SPIRE-MSS-NOT-000770

This technote describes the random vibration response of the SPIRE instrument and its impact on the specification of the random vibration test for the BDA. The note proposes at the end a notching strategy and input levels for the SPIRE instrument.

Figure 2: Random spectrum definition for all 3 directions (x, y and z)

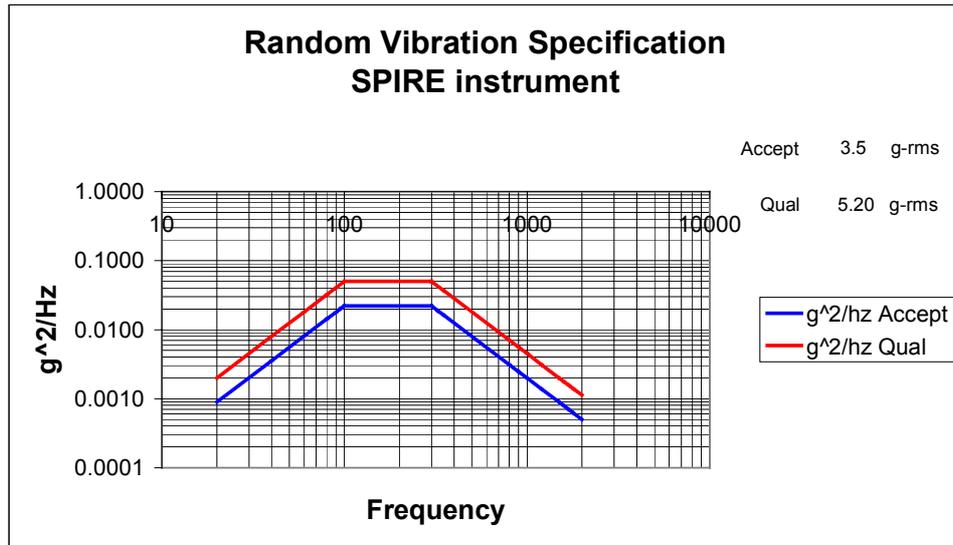
As a first step we applied the required input as specified in the IID-A issue 1.1, which defines the un-notched input at the base of the instrument as pictured in figure 2. (The listed g-rms values in the corner suffer from small numerical errors but are close to the real value.)

1. Allow the instrument to notch, based upon equivalent quasi-static acceleration interface forces
2. Define the required un-notched input as follows:
 - 20 - 100 Hz Ramp up at +6 dB/oct.
 - 100 - 200 Hz $0.05 \text{ g}^2 \text{ Hz}^{-1}$
 - 200 - 300 Hz $0.03 \text{ g}^2 \text{ Hz}^{-1}$
 - 300 - 2000 Hz Ramp down at -6 dB/oct.

Figure 3: Response at the base of the BDA due to un-notched input given in figure 2

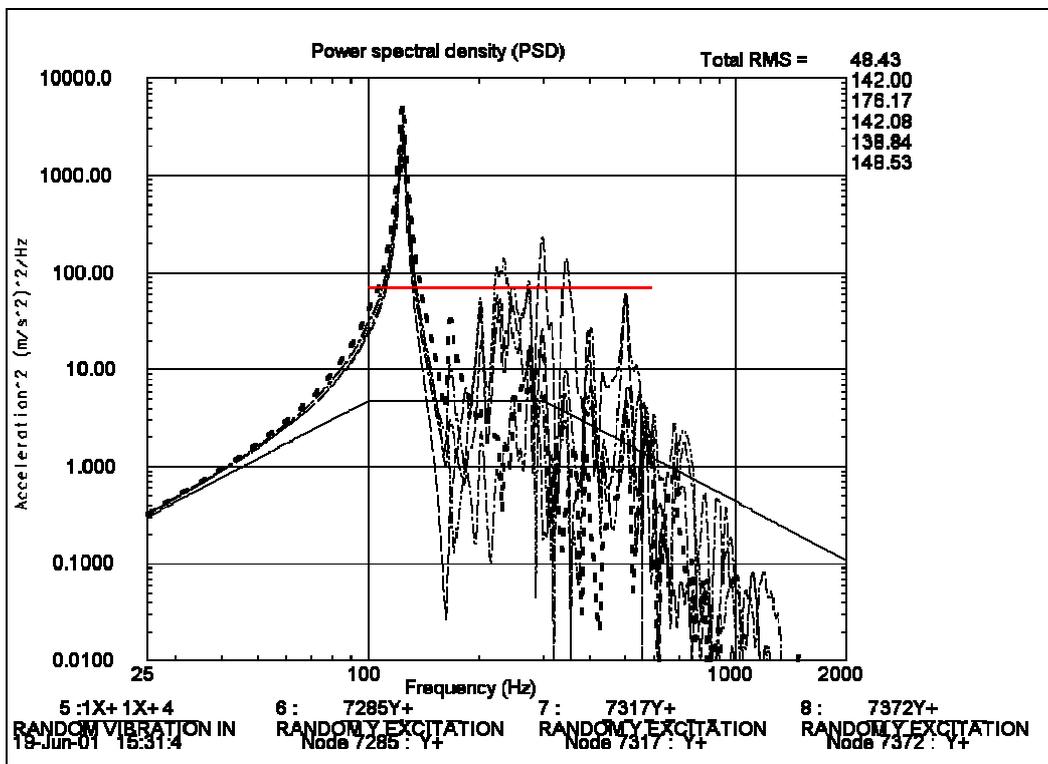
The red line represents the proposed plateau (with +6 dB/oct ramp up and -6dB/oct for the ramp down) for the qualification level BDA input. This is just the Y response to the Y input, the other responses show similar behaviour. The g-rms levels for the various directions, due to the various inputs (not shown here) reach levels of 25 g-rms for X and Z. This is equivalent to 75 g static input in the time domain. However, the BDAs have resonance's in the range of 200 to 400 Hz. Applying the Miles equation (giving the equivalent quasi-static response at resonance) the BDAs will reach levels in the range of 200 g equivalent acceleration. This will undoubtedly break the BDAs. One should note that the BDA will break during their individual sub-system qualification test, the coupled strength analysis with the instrument has not yet been performed. The current design is capable of withstanding accelerations less than 100 g.

- The current random vibration specification for the instrument results in
 - unrealistic high interface forces for the instrument;
 - very high responses for the BDA.
- The BDA can not withstand the specified input during their sub-system test.

Figure 4: Response at the base of the BDA due to notched input given in the same figure (solid black line)

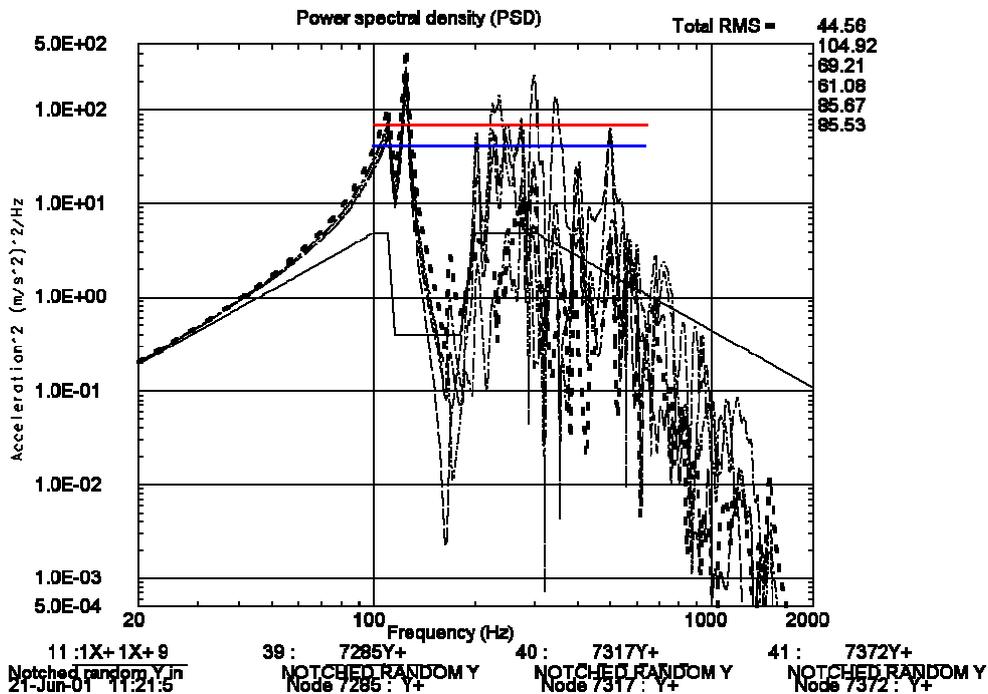
The red line represents again the proposed plateau (with +6 dB/oct ramp up and -6dB/oct for the ramp down) for the qualification level BDA input (now also included the flight level in blue). The g-rms levels for the various directions, due to the various inputs (not shown here) reach levels of 20 g-rms. This is equivalent to 60 g static input in the time domain. However, (again) the BDAs have resonances in the range of 200 to 400 Hz. Applying the Miles equation (giving the equivalent quasi-static response at resonance) the BDAs will reach levels in the range of 200 g equivalent acceleration. This will undoubtedly still break the BDAs. Again note that the BDA will break during their individual sub-system qualification test, the coupled strength analysis with the instrument has not yet been performed.

- acceptable interface forces for the instrument;
- overall reduction in response;
- still high input for the BDA, resulting in unacceptable input levels for the BDA sub-system test.

Based upon these conclusions we decided to allow the BDAs to notch their input at resonance during the sub-system qualification test. However, we cannot allow an overall decrease in input for the BDAs. The design margins are very critical, and the current response of the instrument, even with notched input, produces high loads for the BDAs. This is due to three factors:

Figure A-1: Un-notched I/F force for the three orthogonal directions

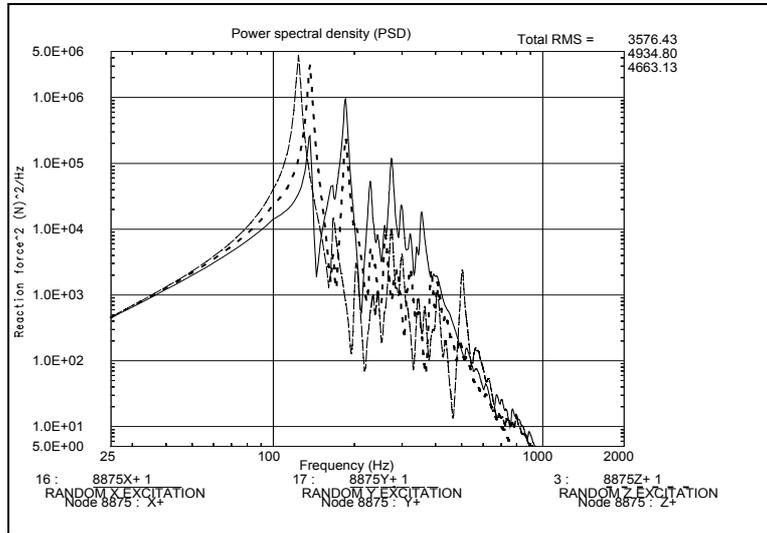
The equivalent quasi-static forces are 7.5 kN, 5.2 kN and 5.2 kN respectively (for this FEA and with an input of 20, 14 and 14 g respectively). We should not exceed the equivalent quasi static interface force with the random time based response. We should therefore not exceed: 2.5 kN in X and 1.7 kN in Y or Z direction. Forces being N-rms are divided by 3 to take into account the 3-sigma variation of the force in the time domain. In order to scale the input for the instrument to obey this boundary condition we notch the primary mode in each excitation direction (modes with significant effective mass > 10% of instrument mass). The resulting interface force is pictured in figure A-3 (compare with figure A-1)
